SERVICE BULLETIN

SB97.12

Axle Float Cylinder

PURPOSE: Install Axle Cylinder Kit # 30858-000

Figure 1

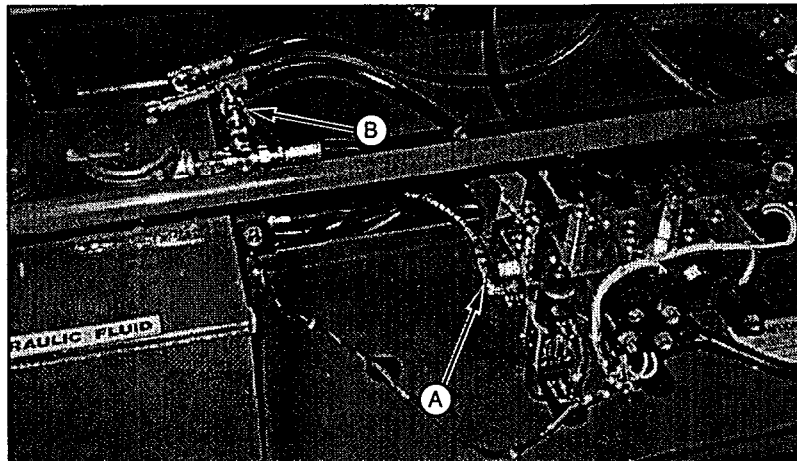
1. Exchange the front wheel motor relief hose connection (A) at the main valve block assembly with the axle cylinder vent hose (B) at the hydraulic reservoir as shown. See figure 1.

Figure 2

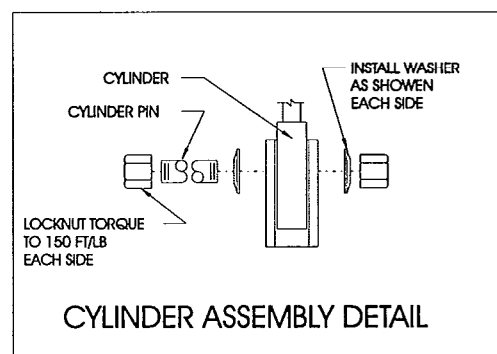
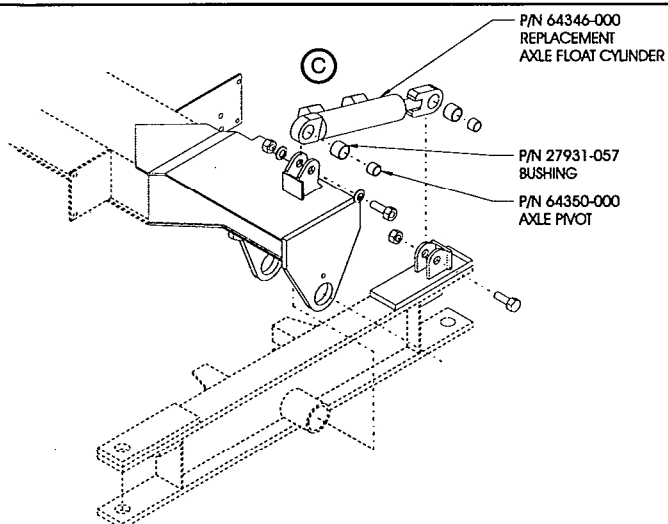
3. Remove the existing axle cylinder (C) and discard. See figure 2.
4. Install the replacement axle cylinder (P/N 064346-000), replacement axle pivot (P/N 064350-000), and bushing (P/N 027931-057), **upper connection only!** Torque retaining nut to 150 ft/lbs. See figure 2.

Figure 3

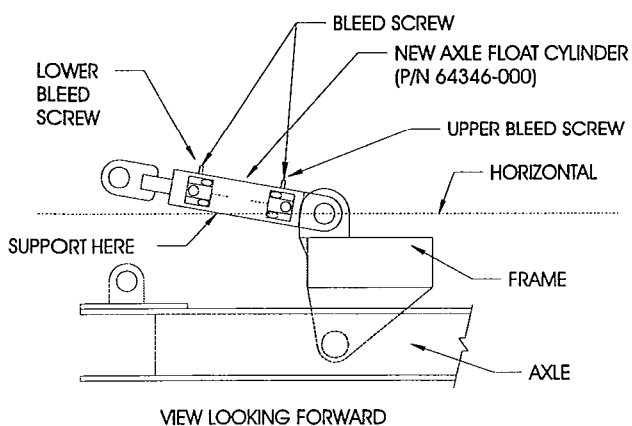
5. Elevate rod end of axle cylinder such that the axle cylinder lower bleed screw is above horizontal. Use suitable device to support rod end of axle cylinder. See figure 3.

6. Open lower bleed screw on axle cylinder. See figure 3.
7. **NOTE:** Make sure drive coils have been disconnected, as instructed in procedure 2. This will prevent drive during bleeding procedure. **CAUTION:** A small amount of hydraulic oil will escape with this procedure. Always wear protective clothing and eye protection when working with hydraulic oil. Actuate drive and close lower bleed screw once **a steady stream of oil** is present.

8. Open upper screw. See figure 3.
9. Manually depress cylinder rod to obtain proper cylinder length for installation.
10. Install lower cylinder connection using replacement axle pivot (P/N 064350-000), and bushing (P/N 027931-057). Torque retaining nut to 150 ft/lbs.

Figure 4

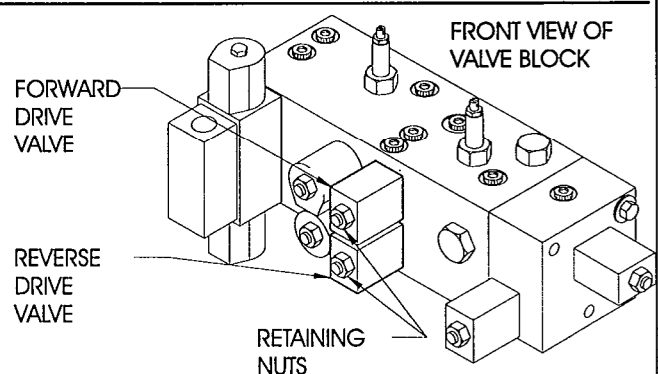
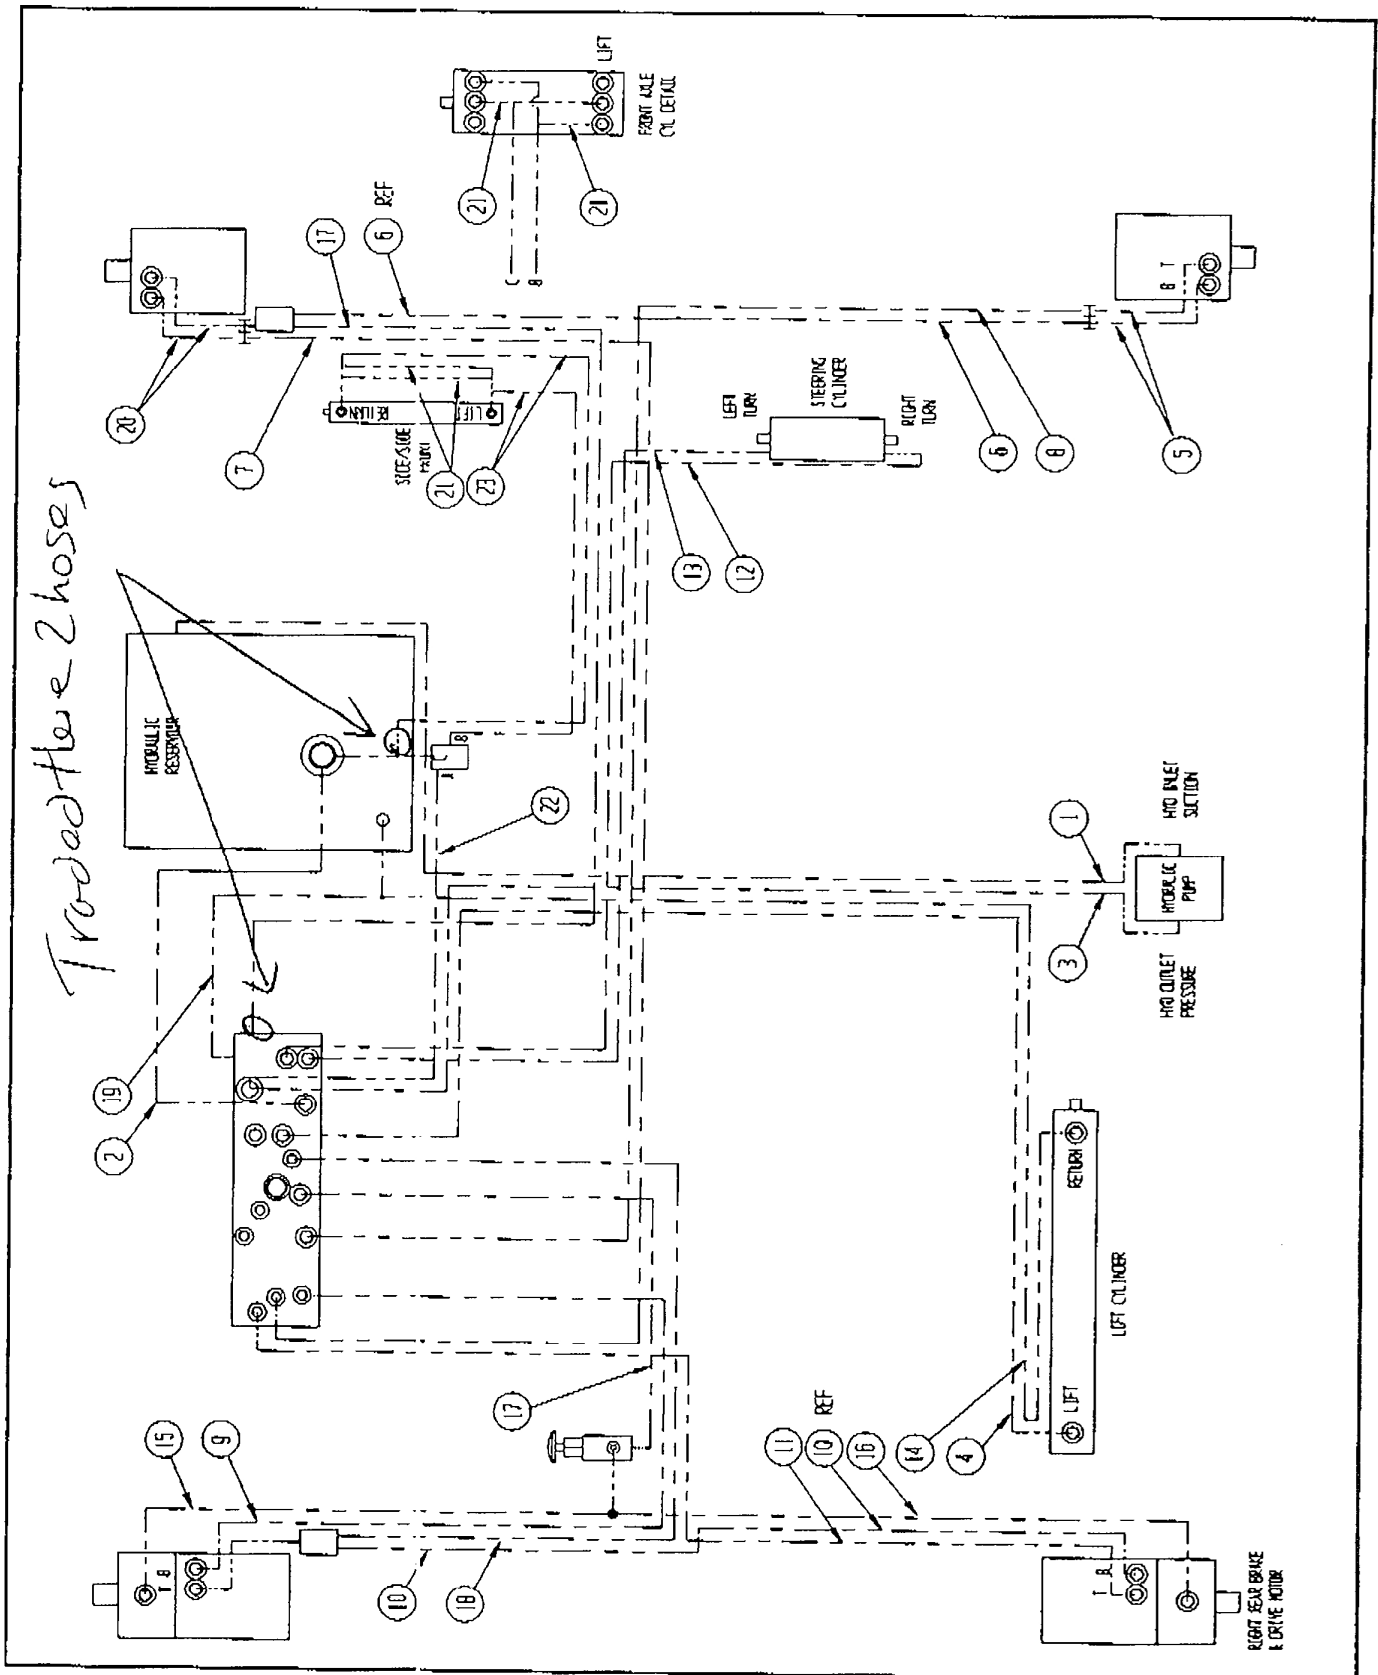
2. Remove retaining nut securing forward and reverse drive coils. Mark drive coils as they are removed so as not to confuse their location during reinstallation. Remove drive coils from valve cartridge. See figure 4.
